That BMROSS work with GSP to provide a revised enhanced design and cost estimate that considers, as much as possible, future operational and capital costs through refinements to sidewalk space, tree and landscape areas, and concrete planter quantities, for the Rebuilding Downtown Infrastructure Project;

**INFORMATION PRESENTED BY GSP AT TASK FORCE MEETING**  
**May 7, 2024**

**INFORMATION RECEIVED**  
Gerry O'Brien – April 7<sup>th</sup>, 2024

## Alternate Proposed Streetscape- Con Melady

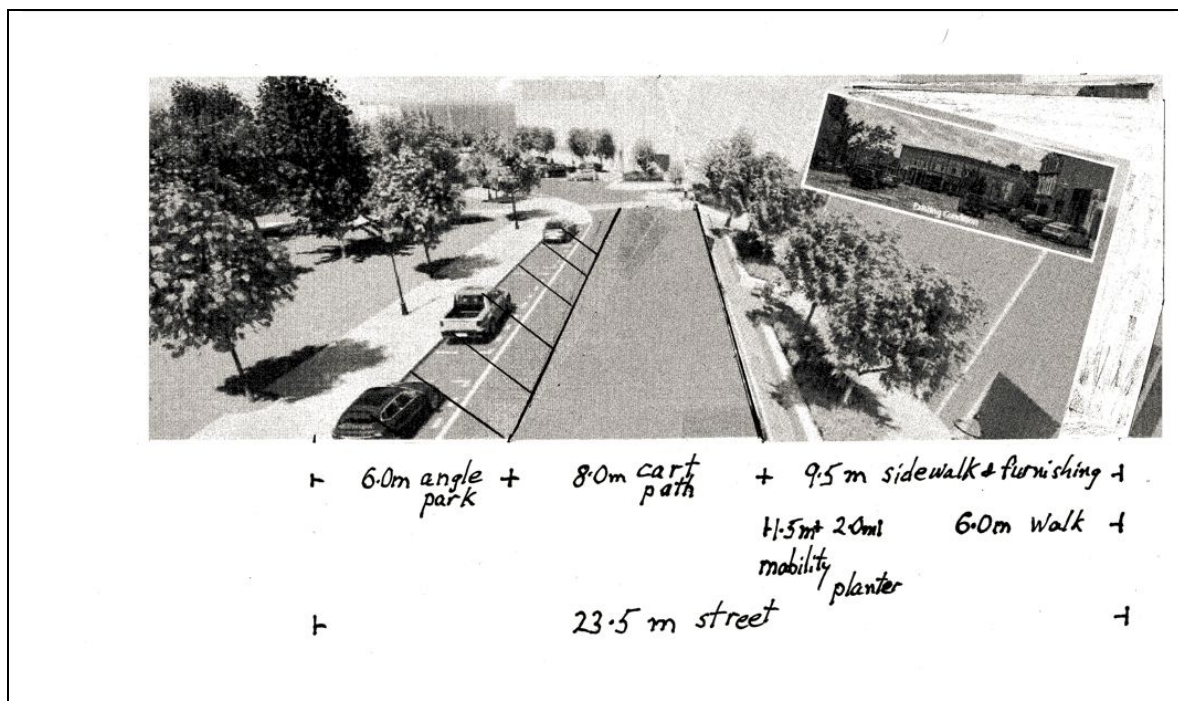
I am offering an amendment to the design that has zero cost associated and has multiple benefits for business and mobility accommodation. It is my hope that these accommodations will lead to a mode shift away from large single occupant motor vehicles and toward non polluting micro- mobility alternatives including active transportation.

The statement that *"Intersections are designed to provide refuge, meet*

*AODA requirements"* supports the pedestrian focused design but **falls short** of taking into account the **mobility needs** of many citizens. (See Appendix 1)

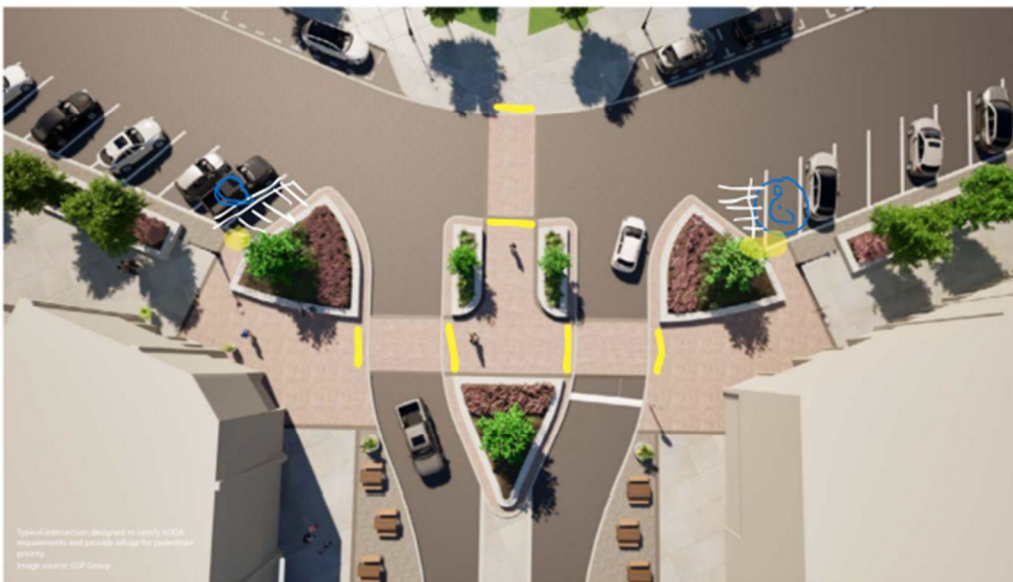
It is obvious to me that the teams tasked with the Goderich Downtown project have not started with accessibility in mind. If this were the case, then disability and accessibility would be represented *even at the concept drawing stages*. To elaborate: parking, outdoor eating, shade, traffic calming, and active transportation are all concepts that were brought to the attention of the project team during the charette. All of these concepts are represented in the drawings. Accessibility is also a concept that was discussed during the public meetings; however, accessibility is not represented, anywhere, on the concept drawings.

The following images are from the report: image one is an overhead view of the intersection "concept"; image two shows rudimentary markings that I have added to show how accessibility as a concept would be represented. In blue and white ink, accessible parking is shown at each side of the intersection, and tactile warning indicator surfaces are shown in yellow ink.

This second set of images shows the public eating area concept (1) and (2) the same, but with disability and accessibility represented. Yellow ink is used to show tactile warning indicator surfaces at the crosswalks and I've added an

image of a person using a wheelchair seated at a picnic table with an extension on the end that makes it accessible.

I am requesting that Council make a motion to require accessibility best practices be added to the terms of reference given to BMRoss and GSP for the Goderich Downtown reconstruction project and that it be done by:

1. Involving an accessibility professional from this point forward until the completion of the project.
2. Design and construct beyond the current AODA standards, applying best practices for accessibility to the entire project.
